Interactive comment on “Evaluating the streamflow simulation capability of PERSIANN-CDR daily rainfall products in two river basins on the Tibetan Plateau” by Xiaomang Liu et al.

Received and published: 2 October 2016

Fig. 1. Authors' Reply to Comments Figure 1

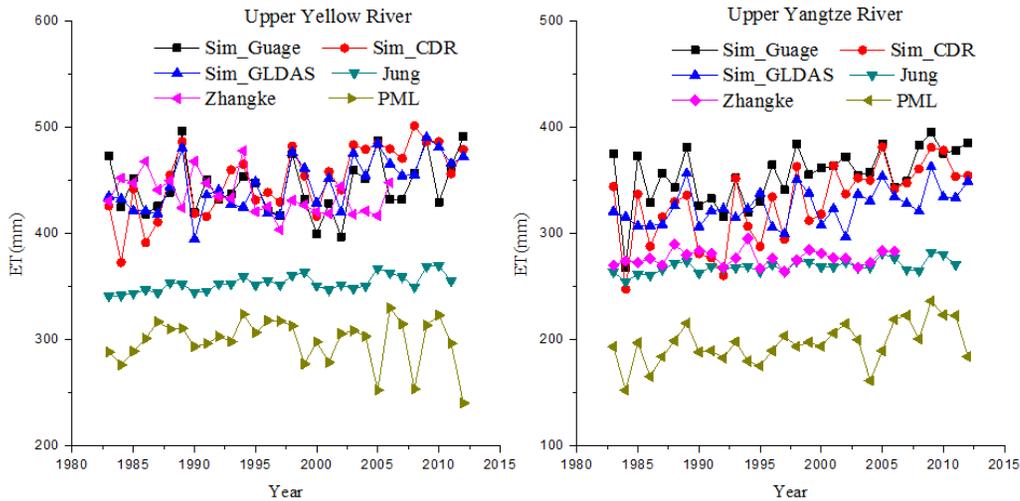
(3) It is hard to compare the hydrological model's performance with only the basin integrated streamflows. Suggest adding the comparisons of simulated evapotranspirations (ET) as well, to confirm the improvements of internal processes besides the final discharge outputs. For the ET estimation over the two river basins, suggest reading (but not limited to) the following papers: Zhang, Y. et al. (2007), Trends in pan evaporation and reference and actual evapotranspiration across the Tibetan Plateau, *J. Geophys. Res.*, 112, D12110. Xue et al. (2013), Evaluation of evapotranspiration estimates for two river basins in Tibetan Plateau by a water balance method, *Journal of Hydrology*, 492, 290-297. Li et al. (2014), Seasonal evapotranspiration changes (1983–2006) of four large basins on the Tibetan Plateau, *J. Geophys. Res. Atmos.*, 119, 13079–13095.

authors' arguments. After all, the streamflow and evaporation are two of the major components of water cycle. The hydrological model should be able to provide such information. (iii) In author's reply to reviewer #1, authors also agree to provide the evaporation simulation/comparison in the revised manuscript. I am also interested to see the simulation results and comparison with other data sources.

Answer: Thank you for your suggestion. We totally agree that adding evapotranspiration (ET) comparisons can be a good supplement to verify hydrological model's performance. The following figure shows the simulated ET from ground-based precipitation, GLDAS precipitation and PERSIANN-CDR precipitation by HIMS hydrological model and different ET products from Jung (2010), Zhang K. et al. (2010) and Penman-Mentieth-Leuning (Leuning et al., 2008; Zhang Y. et al., 2016). We tried to compare and judge the different ET estimations, but we find that we maybe do not have a reliable reference for ET comparisons, because large-scale ET cannot be measured directly. Generally, large-scale ET estimated by water balance equation is a good reference. However, rainfall gauge information is limited in the TP as we mentioned in the manuscript, and we cannot use the limited ground-based precipitation to calculate basin reference ET based on water balance equation. Similar philosophy applies to other data-sources of precipitation. In other words, we can either use GLDAS precipitation nor PERSIANN-CDR precipitation to calculate basin reference ET based on water balance equation, because it would be unfair to compare these ET values with ET simulation from ground-based precipitation by HIMS hydrologic model. The purposes of this manuscript are to evaluate the streamflow simulation capability of PERSIANN-CDR daily rainfall product. Therefore, we prefer to not present the ET results in the manuscript to avoid using any non-reliable ET estimation as reference to evaluate any

precipitation products. Readers who are interested in the ET simulation can see the following figure, since all the discussion processes are permanently stored online of HESS Journal. Generally, the following figure shows that the simulated ET from the three precipitation datasets by HIMS model have better consistency in the upper Yellow River basin than in the upper Yangtze River basin. ET from Jung (2010) and PML (Leuning et al., 2008; Zhang Y. et al., 2016) are significantly smaller than ET simulated by the three precipitation based on HIMS model.
